Illinois Department of Transportation
2300 South Dirksen Parkway / Springfield, Illinois / 62764

Subject: Revision #215

Date: August 20, 2013

Revision #215 of the Highway Standards, effective January 1, 2014, is now available on the Department's website.
The revisions are as follows:

STANDARD 701601–09

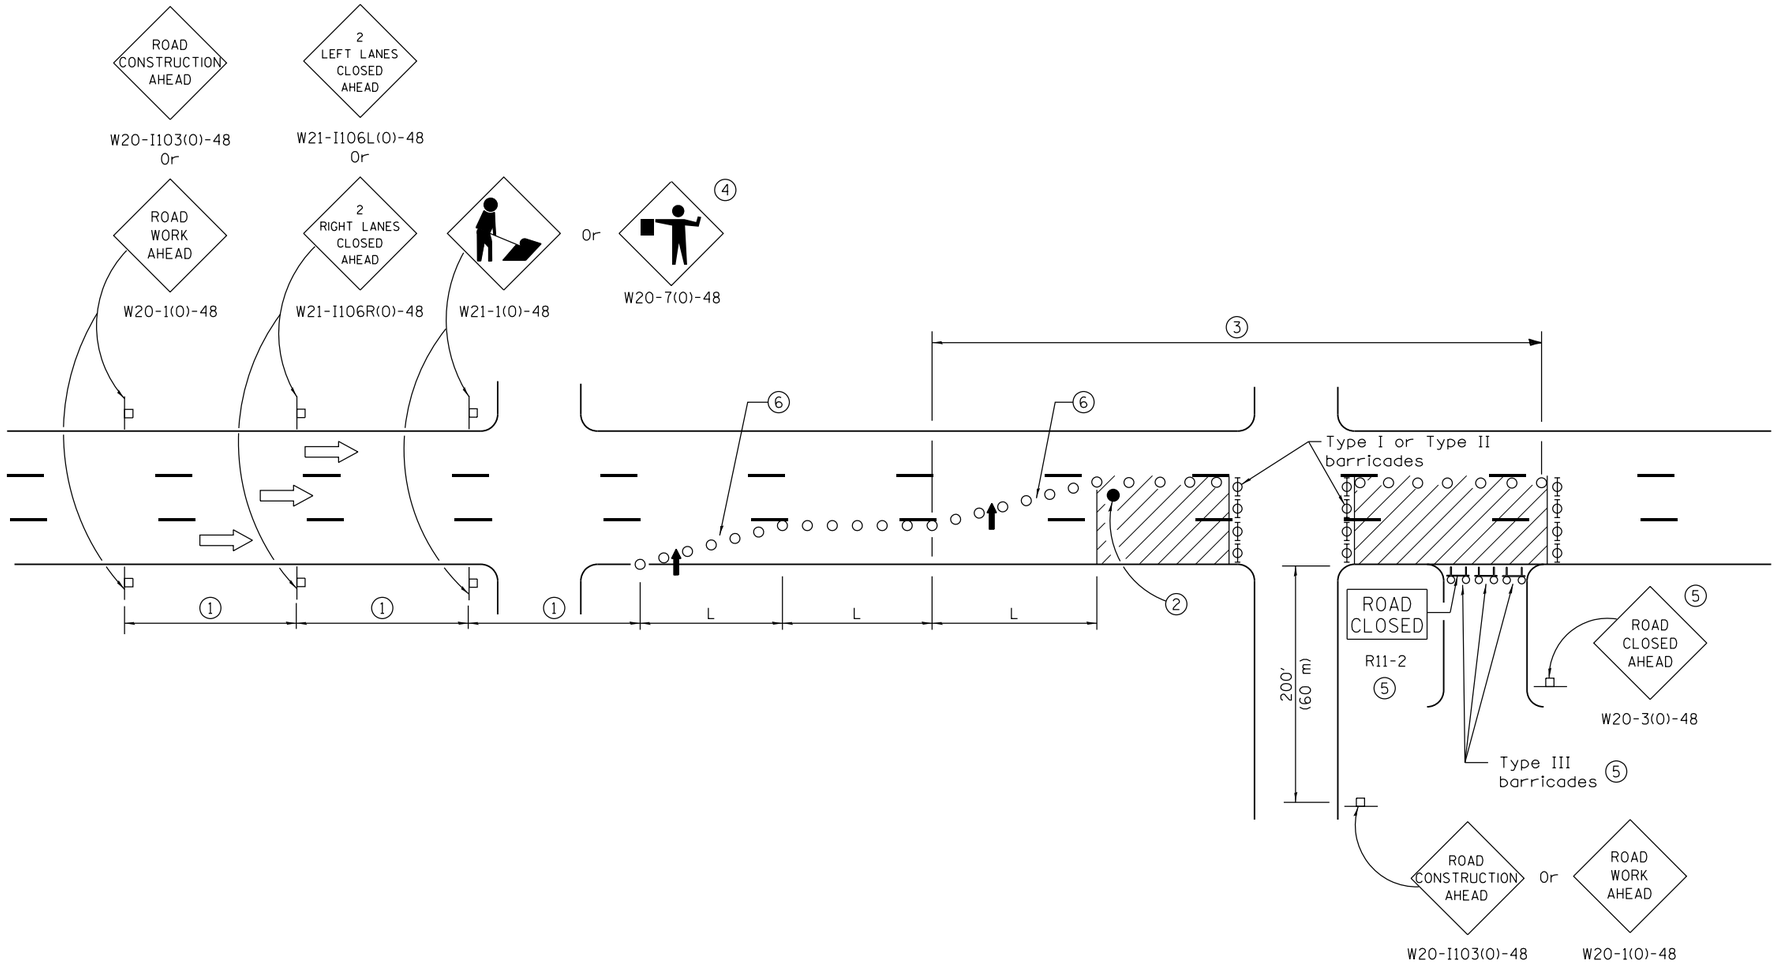
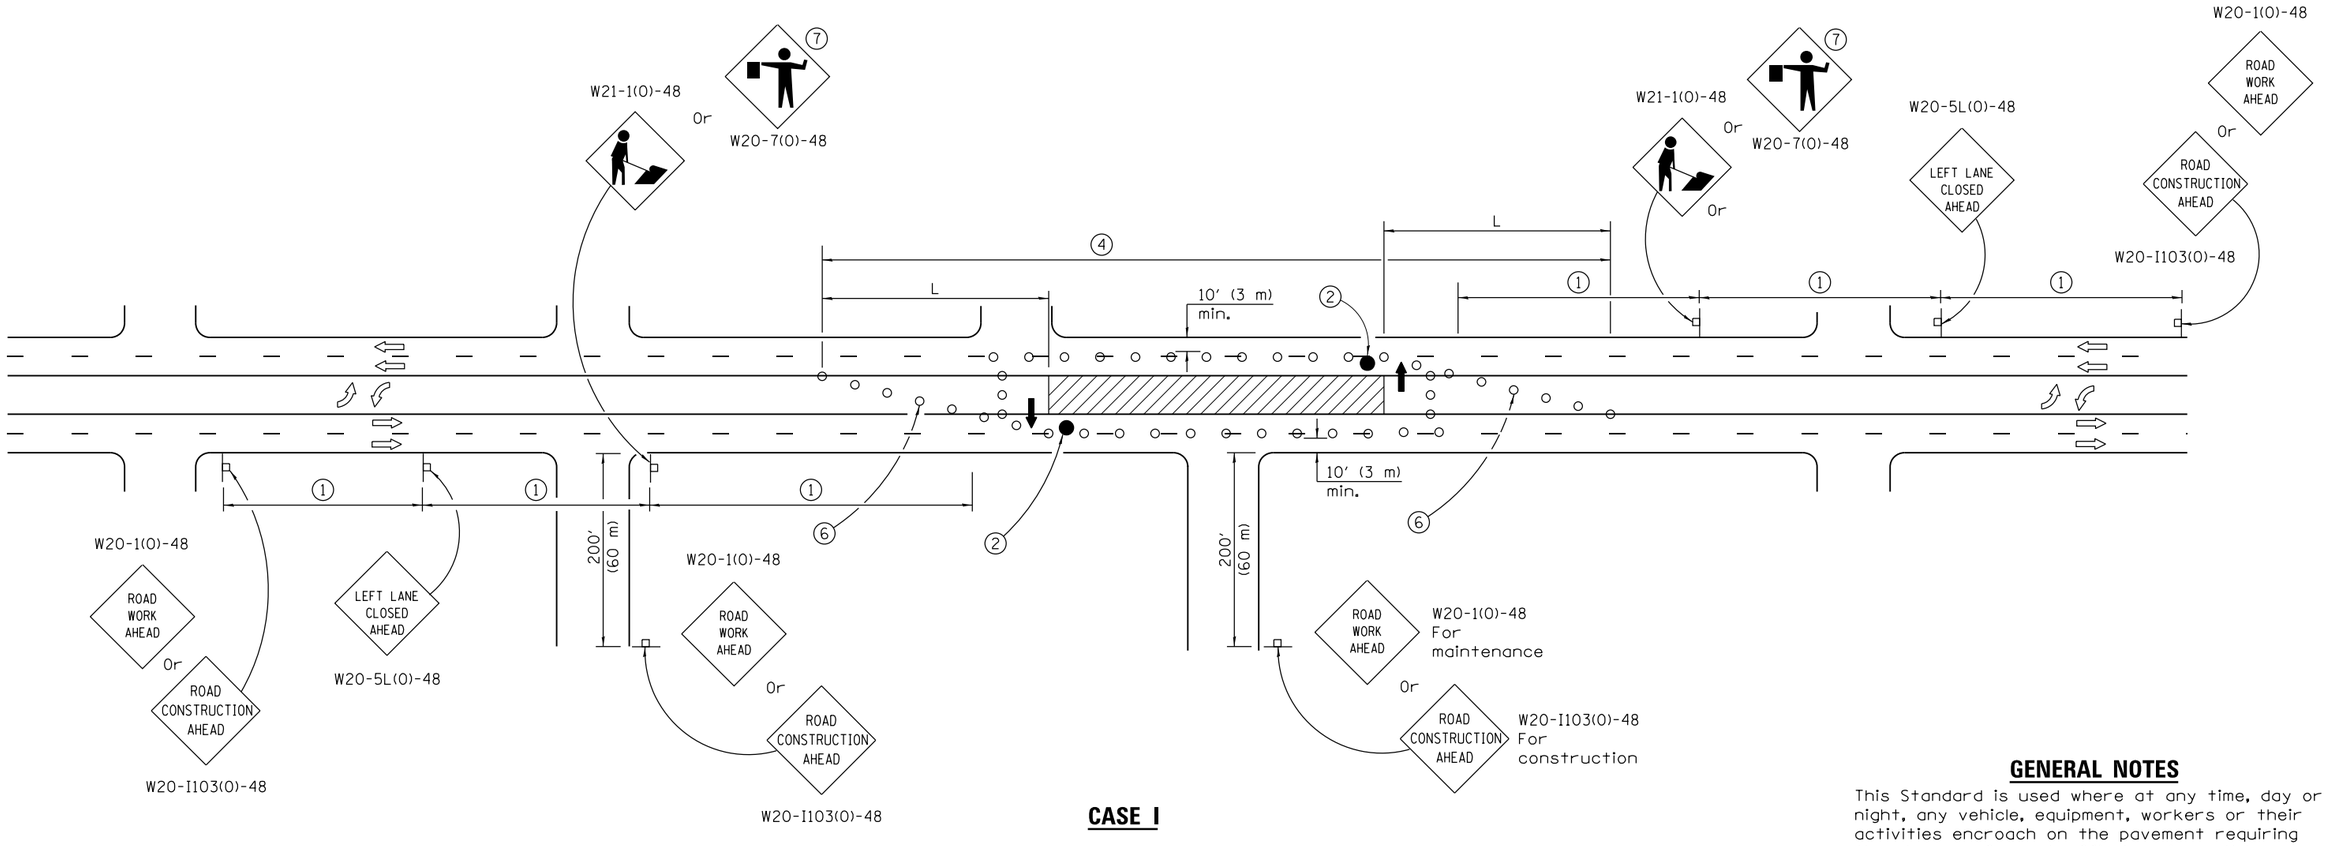
Removed	Inserted	Remarks
701423-06	701423-07	Revised worker sign number to agree with current MUTCD. Revised photo enforced sign number.
701426-05	701426-06	Corrected sign in DETAIL B. Added '±' to distances behind shadow vehicles.
701427-01	701427-02	Added '±' to distances behind shadow vehicles. Corrected note reference for WET PAINT sign.
	701428	New standard.
701431-08	701431-09	Added devices at arrow board. Revised Symbol Legend. Added note '3'. Deleted dimension 'T'.
701446-04	701446-05	Revised photo enforced sign number. Revised note '1' to agree with current MUTCD.
701451-01	701451-02	Revised entrance ramp closure. Changed sign spacing on exit closure.
701456-02	701456-03	Changed dimensions of 'on ramp' sign to 36" x 36". Deleted G20-2 and W13-1 signs. Added dimension at work area.
701502-05	701502-06	Revised worker sign number to agree with current MUTCD. Revised SIGN SPACING table.
701601-08	701601-09	Revised worker sign number to agree with current MUTCD.

STANDARD 701602-07

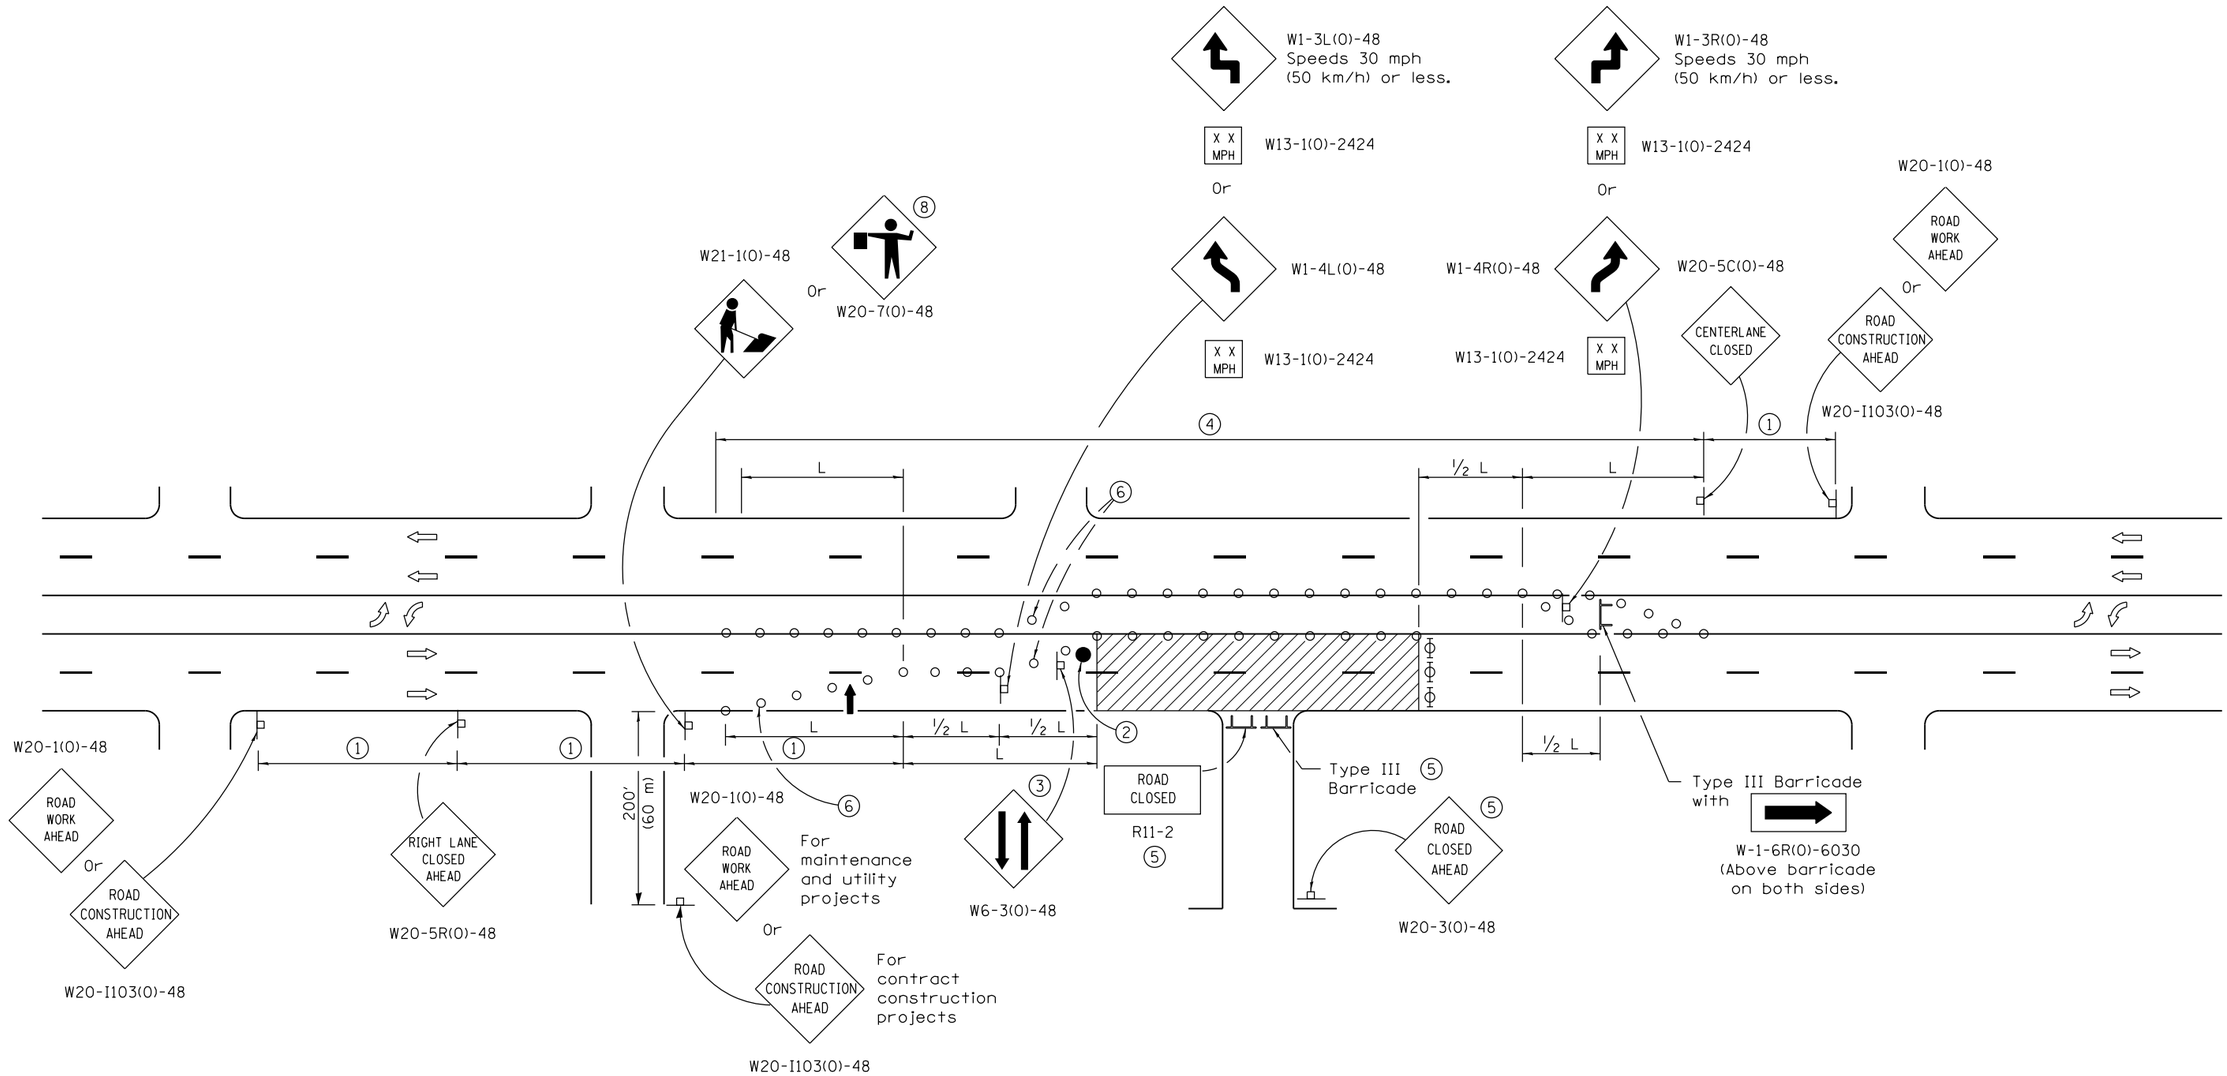
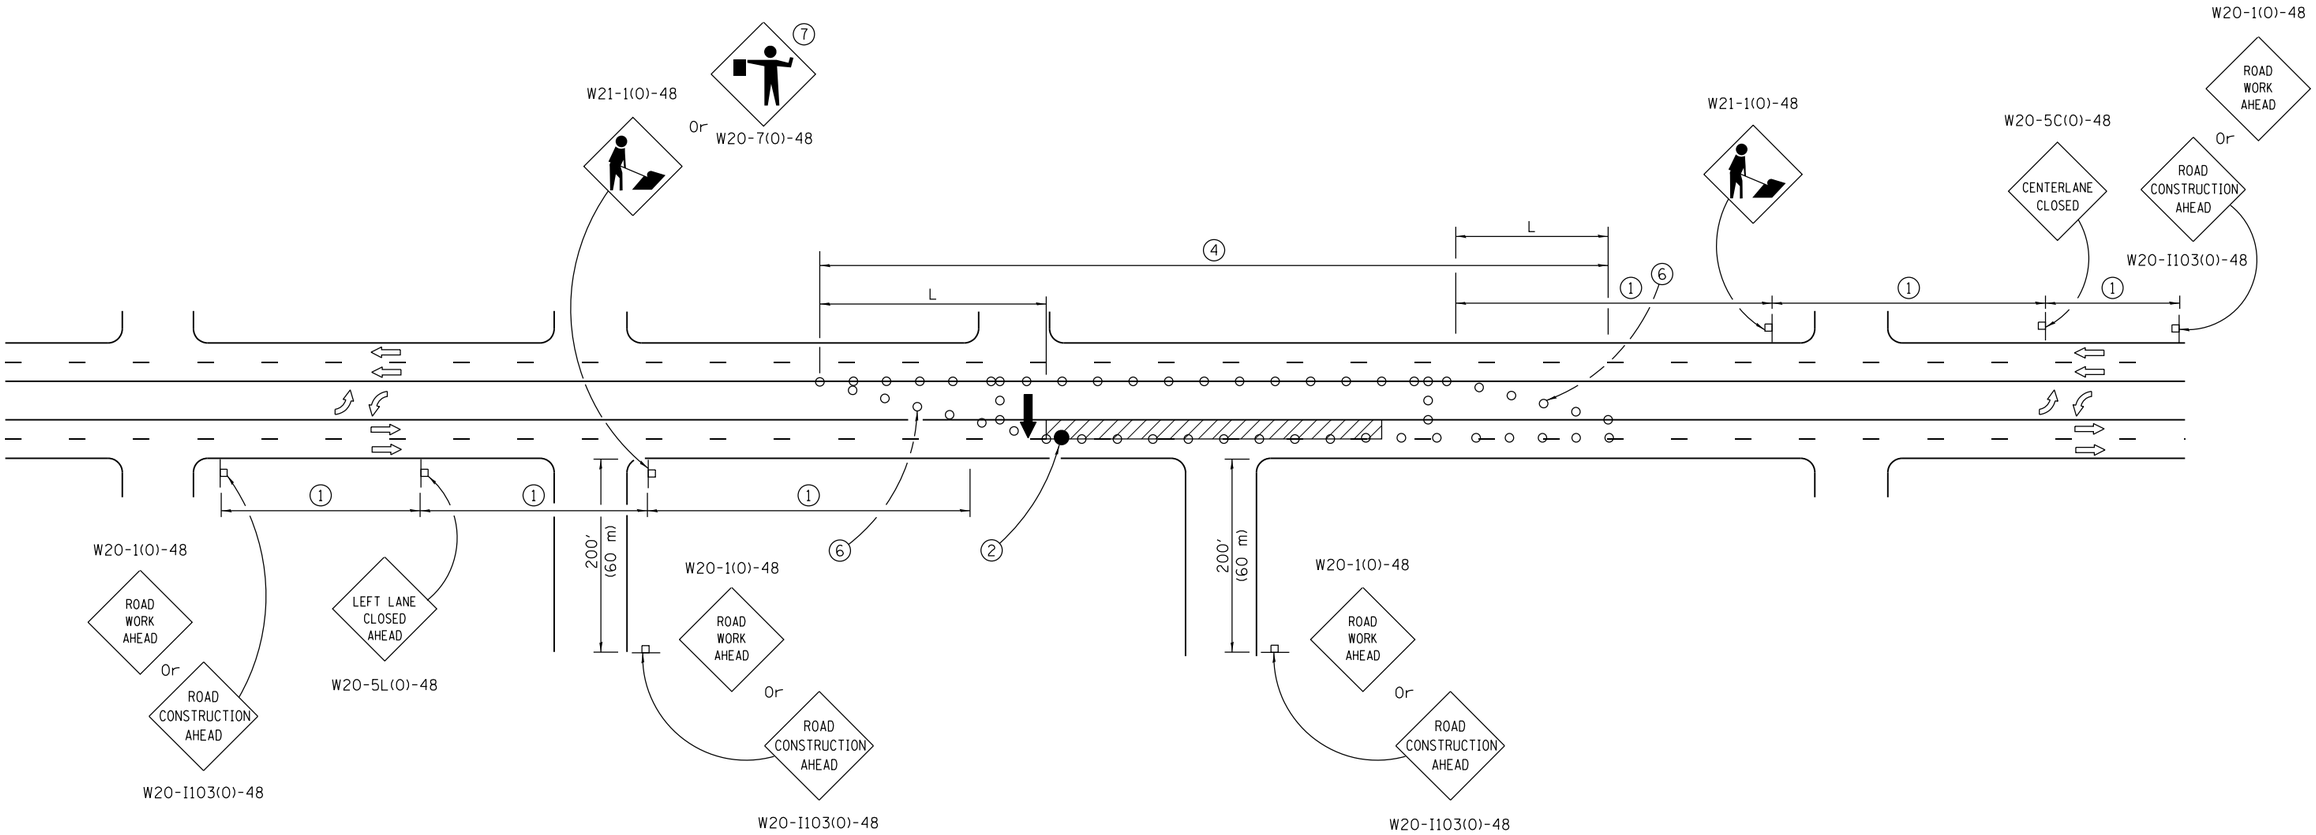
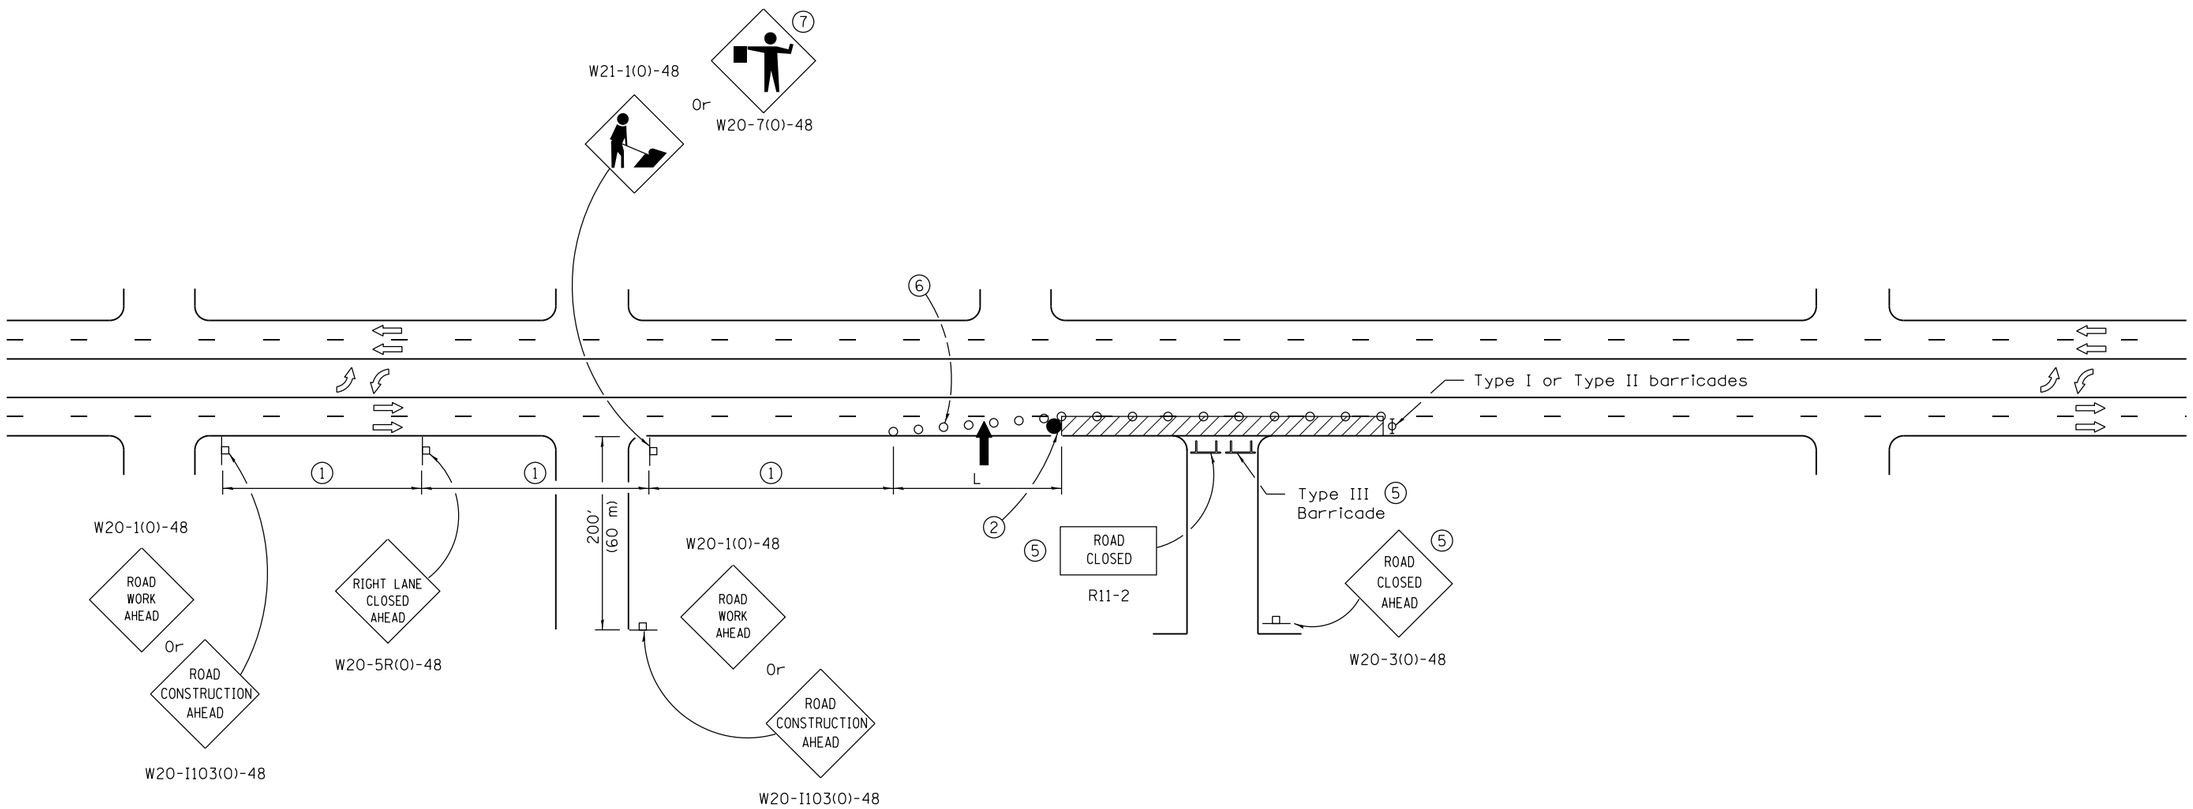
701602-06	701602-07	Revised worker sign number to agree with current MUTCD. Revised SIGN SPACING table.
701606-08	701606-09	Revised worker sign number to agree with current MUTCD.
701701-08	701701-09	Added devices at arrow board upstream from taper. Revised worker sign number to agree with current MUTCD.
701901-02	701901-03	Modified flagger sign height. Added construction zone speed zone signs.
